**ADDENDUM  
NO. 02**

**March 14, 2022**

**Warren Central High School Phase 3 Renovation and Addition  
9500 E. 16<sup>th</sup> Street  
Indianapolis, IN 46229**

This Addendum consists of Pages ADD 2-1 through ADD 2- 5, and attached CSO Architects Addendum No. 2 , dated March 13, 2023, consisting of 11 Pages, Specification Section 02 01 00 – Maintenance of Existing Conditions, and Addendum 2 Drawings: C101, C102, C401, C501, C502, C503, LD001, L101, L106, L201, L206, L301, L306, S201PRT, S202PRT, S501, S601, AD201N, A201M, A201N, A202N, A211G, A211M, A211N, A401, A404, A423, A431, A432, A600, A601, A602, A603, A611, A612, A701, A702, A703, A800, A801F, A801J, A801M, A801N, A801P, A801R, A801T, A802F, A802N, A802P, A802R, A802T, A900A, A900B, A901K, A902U, A903, A904, A905, A906, MD201F, MD201H, MD201J, MD201K, MD201L, MD202HJ, MD202N, M201F, M201J, M201K, M201L, M201N, M202HJ, M202N, M211F, M211H, M211J, M211K, M211L, M211N, M212HJ, M301, M303.

---

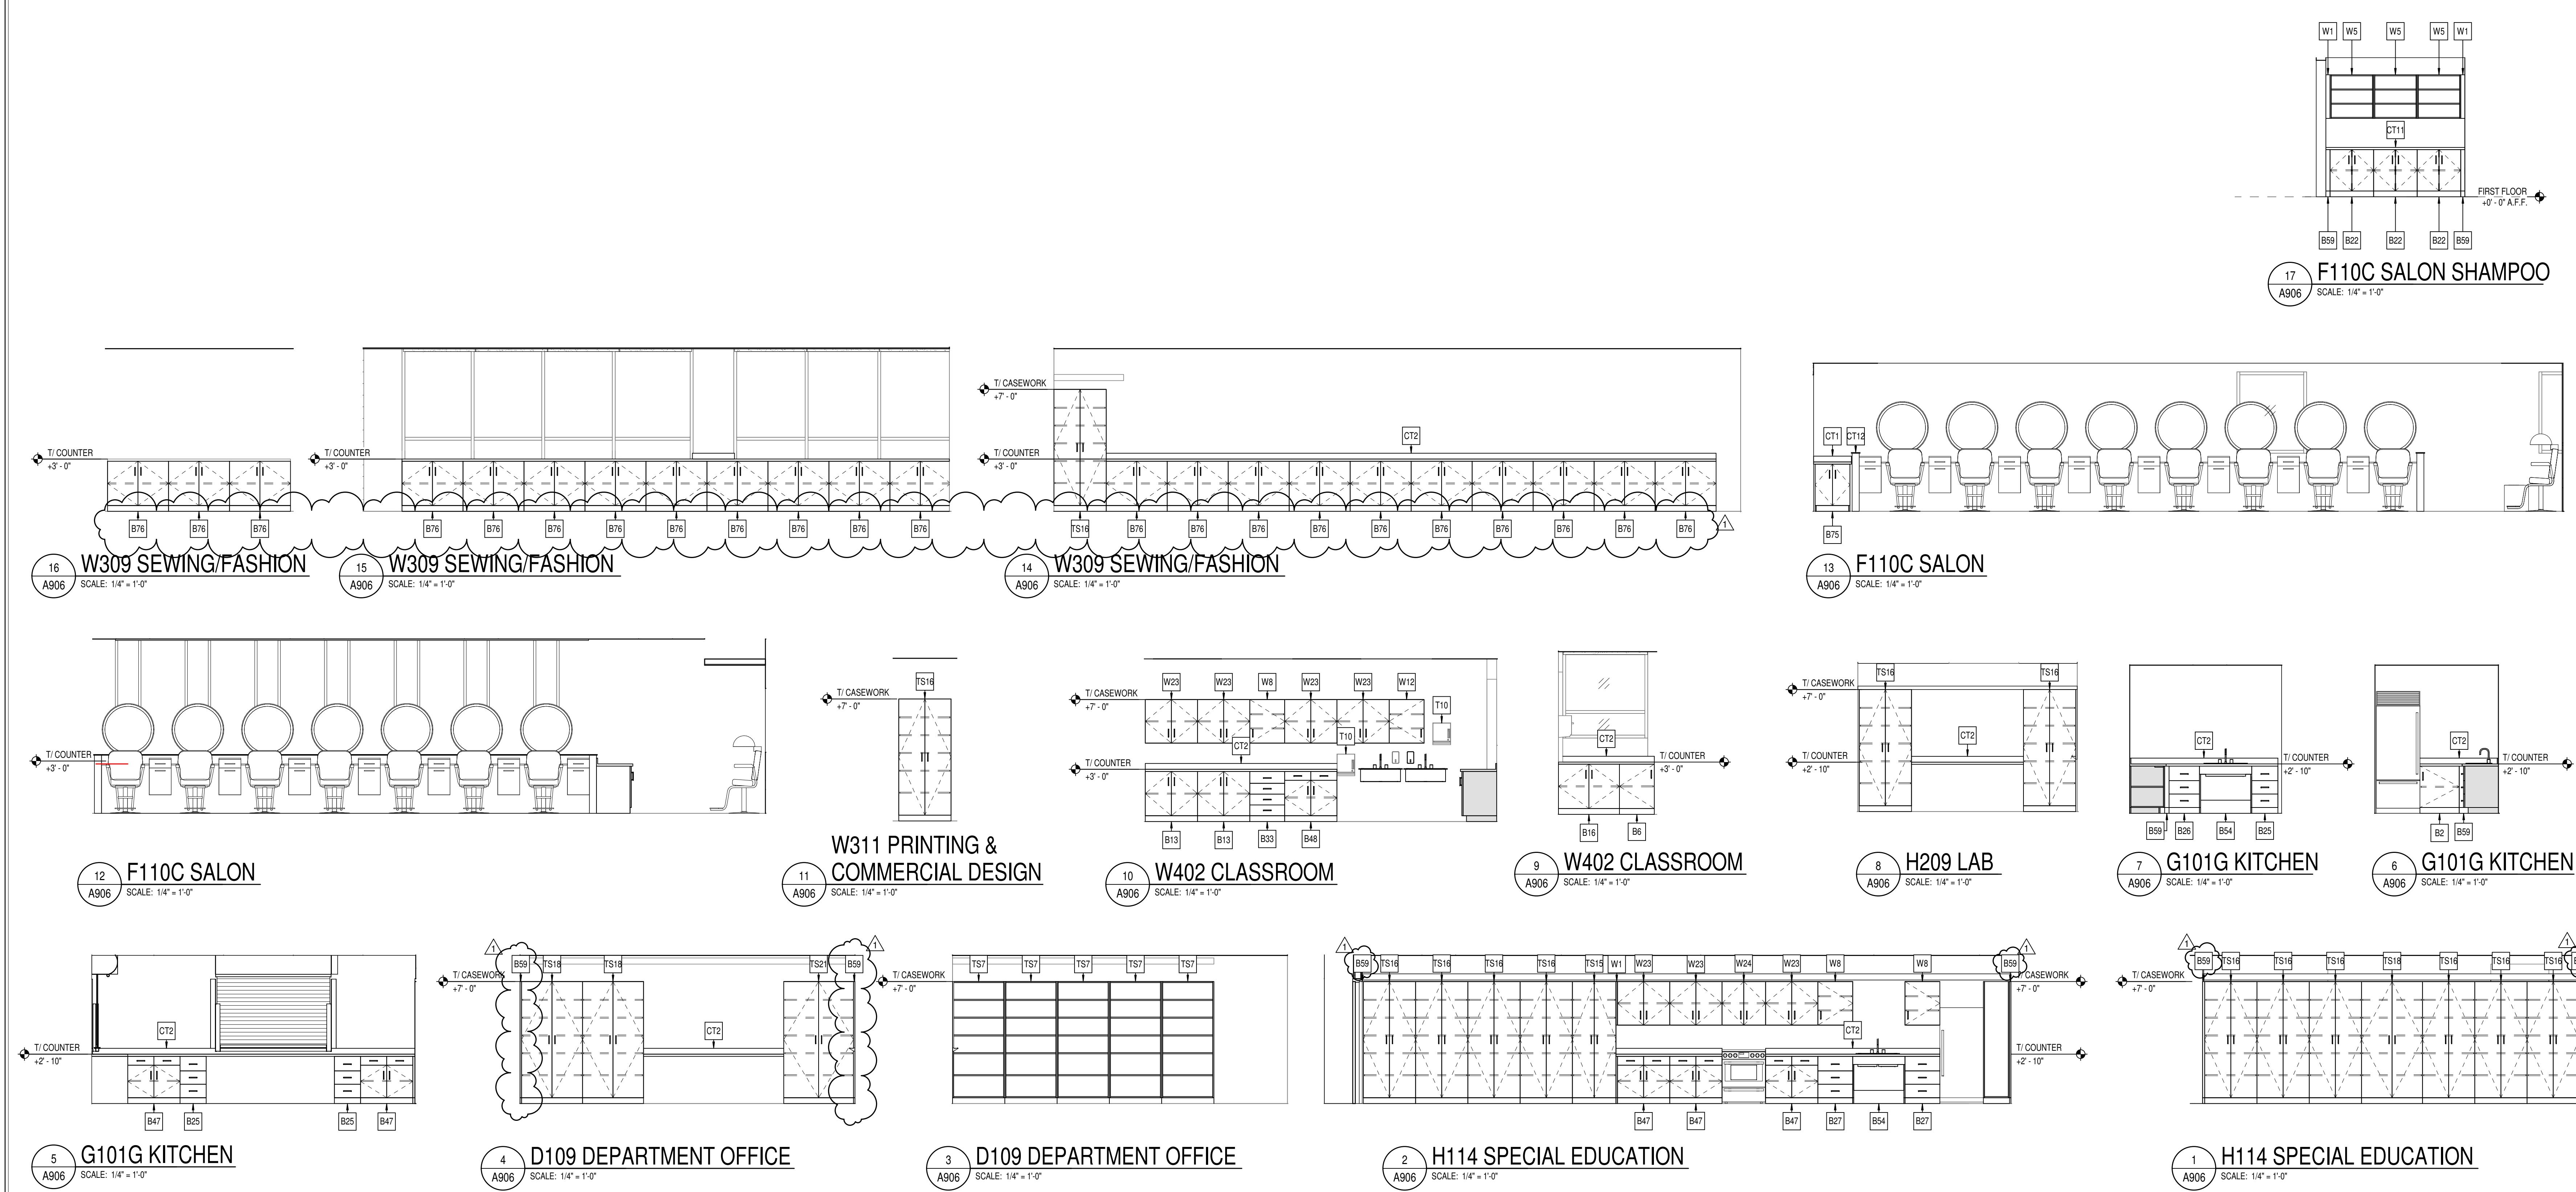
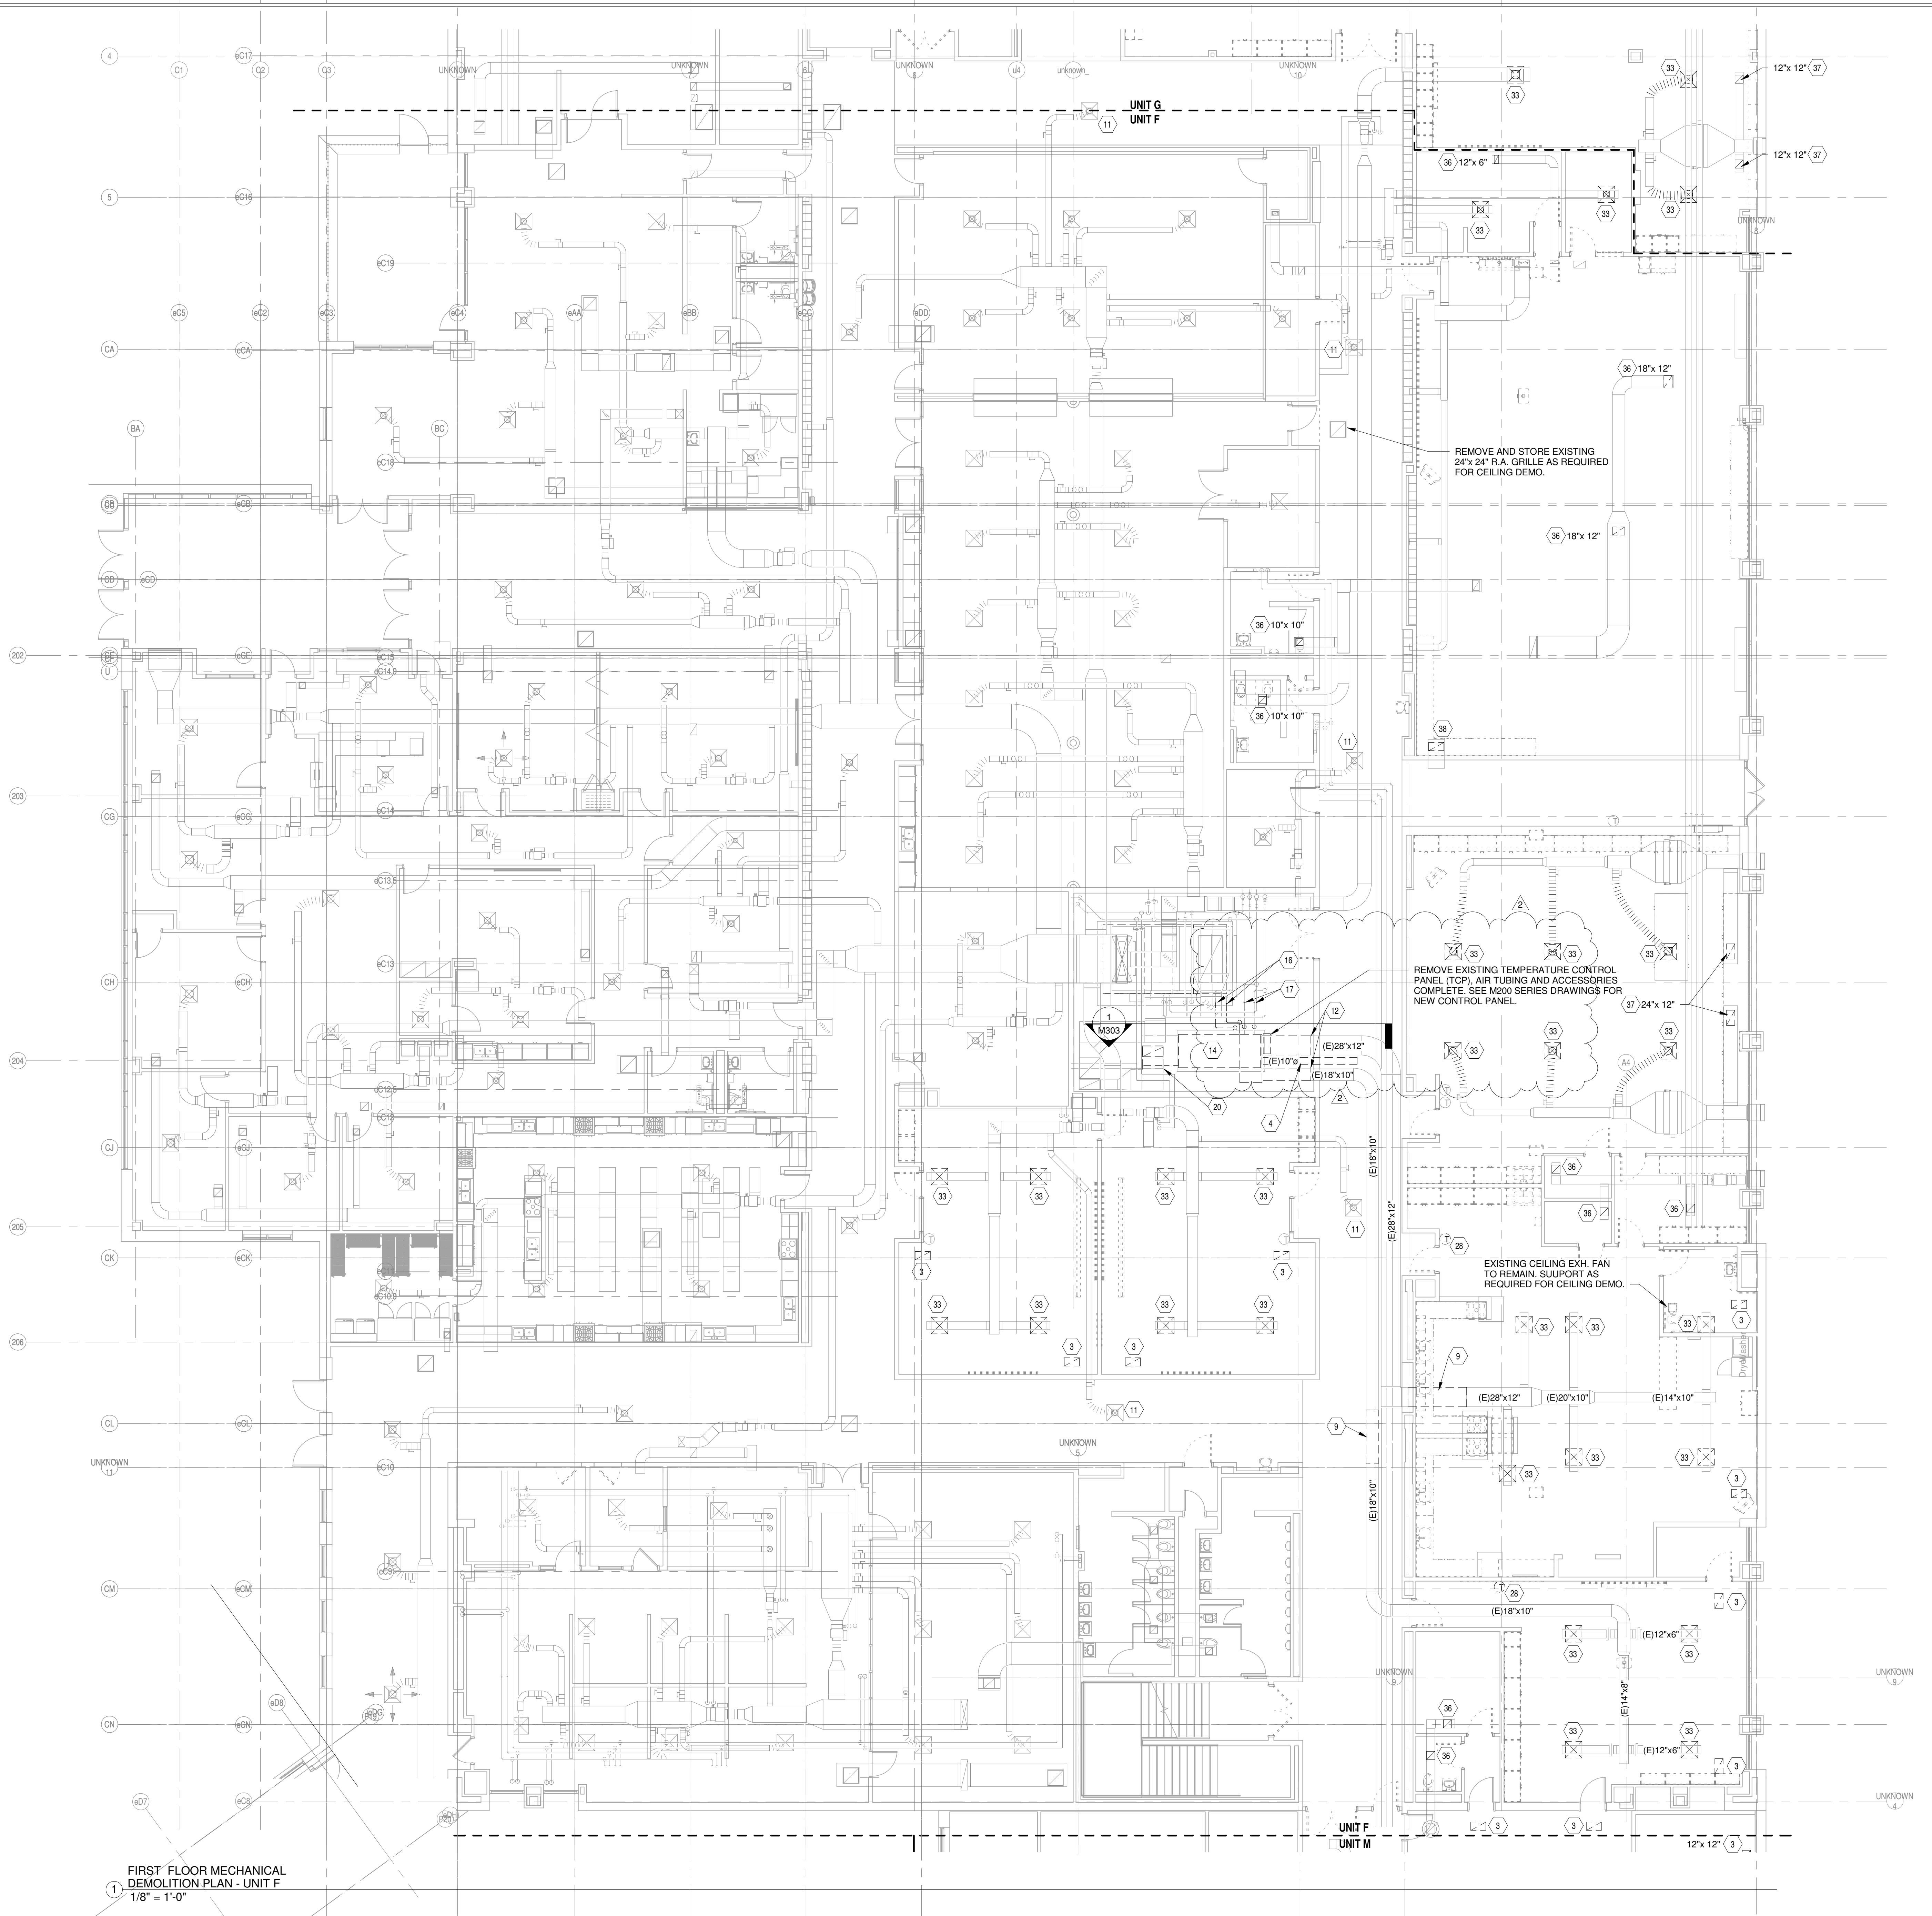
- A. REVISE interior elevations as indicated on attached, re-issued Sheet A903.
